SERVICE BULLETIN

TITLE: FLIGHT CONTROLS - CONTROL COLUMN HARDWARE REPLACEMENT

This Service Bulletin provides instructions to install a new hardware configuration in the pilot's control column.

**Proper Orientation of Flat on Guide Assembly
Figure 4**

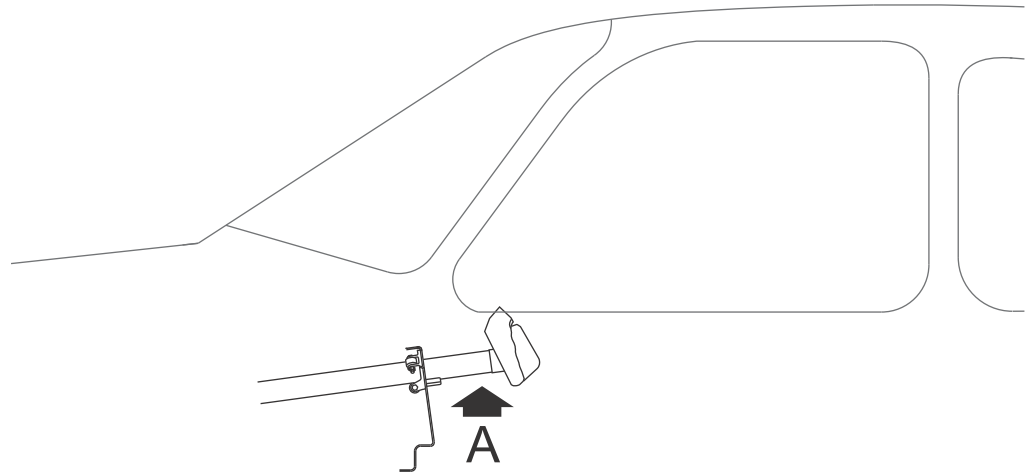
- (ii) When the bolt is partially threaded into the nutplate, rotate the tongue depressor and guide assembly so that one of the flats of the guide assembly is at the bottom of the control column. Refer to Figure 4.

- (iii) Leave the tongue depressor in place to hold the guide assembly in position during the process of torquing the bolt to 50-70 inch-pounds over the free running bolt torque.

Figure 1

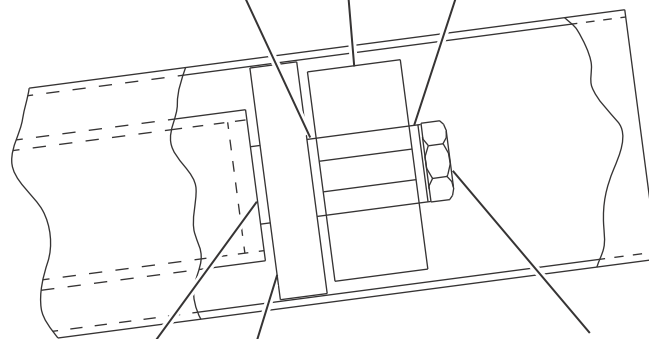
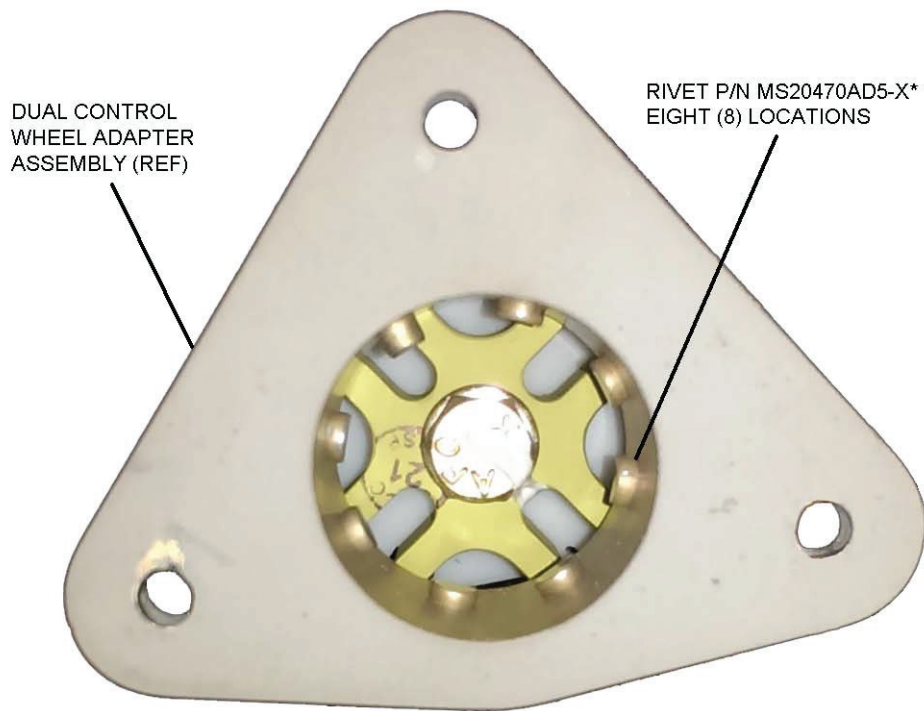
INSTALL 36-524091-15 SPACER, APPLICABLE TO BONANZA
INSTALL 36-524091-17 SPACER, APPLICABLE TO BARON

REMOVE AN960-416 WASHER
INSTALL MS35338-44 WASHER

INSTALL 2 MS35335-33 LOCK WASHERS

REMOVE AN960-416 WASHER
INSTALL MS35335-35 LOCK WASHER

REMOVE EXISTING AN4-24A BOLT
INSTALL NEW AN4-24A BOLT, APPLICABLE TO BARON
REMOVE EXISTING AN4-14A BOLT
INSTALL NEW AN4-14A BOLT, APPLICABLE TO BONANZA
TORQUE BOLT 50-70 IN-LBS

60-524101-5
INSTALL NEW GUIDE ASSEMBLY

- (f) Apply chemical conversion coating to bare metal surfaces. Allow adequate drying time following application of chemical conversion coating.
 - (g) Remove bolt P/N AN4-24A (Baron) or bolt P/N AN4-14A (Bonanza), from the center of the control column. Refer to Figure 1.

- (h) Remove the following items from the bolt:
 - Washer P/N AN960-416. Discard washer.
 - Guide assembly P/N 60-524101-0005. Discard guide assembly.
 - Washer P/N NAS1149F0463P. Discard washer.

- Spacer P/N 36-524091-15 (Bonanza) or P/N 36-524091-17 (Baron). **Retain the spacer.**
 - (i) Discard the bolt.
- (3) Refer to Figures 1 through 4 and reassemble the control column as follows:

Control Column Rivet Installation
Figure 2

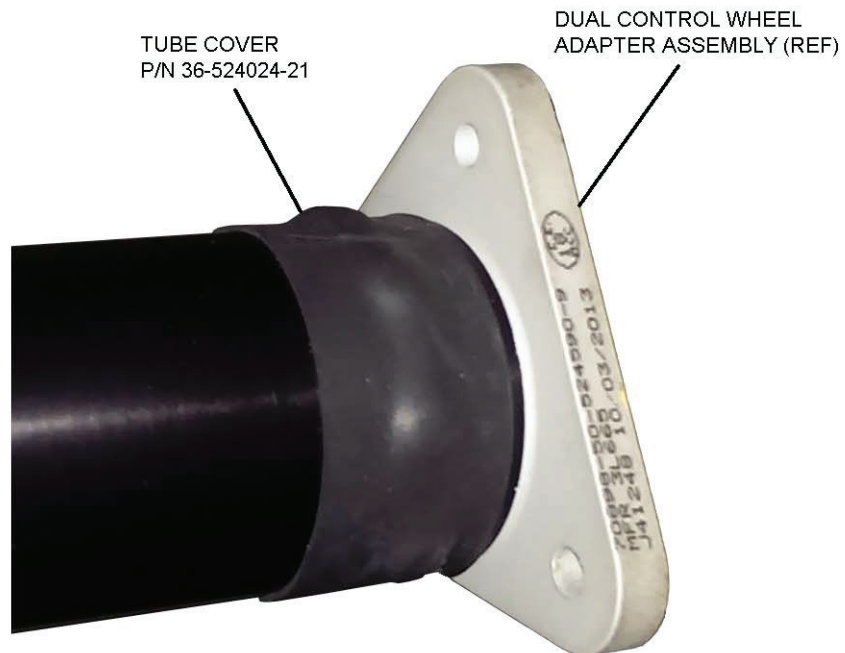
- (a) Remove the pilot's control wheel from the control column.
- (b) Remove the control column tube cover (heat shrink).
- (c) Drill out eight (8) rivets that are attaching the control wheel adapter to the control column. Refer to Figure 2.
- (d) Mark the orientation of the adapter on the control column prior to removing the adapter. Remove the adapter.
- (e) Ensure the control column is clear of metal shavings, fasteners, and other loose material.

- (j) Install a new tube cover, P/N 36-524024-21, on control column. Leave control column rivet holes uncovered. Refer to Figure 3.
- (k) Using eight (8) new rivets, P/N MS20470AD5-X*, install the adapter to the control column.
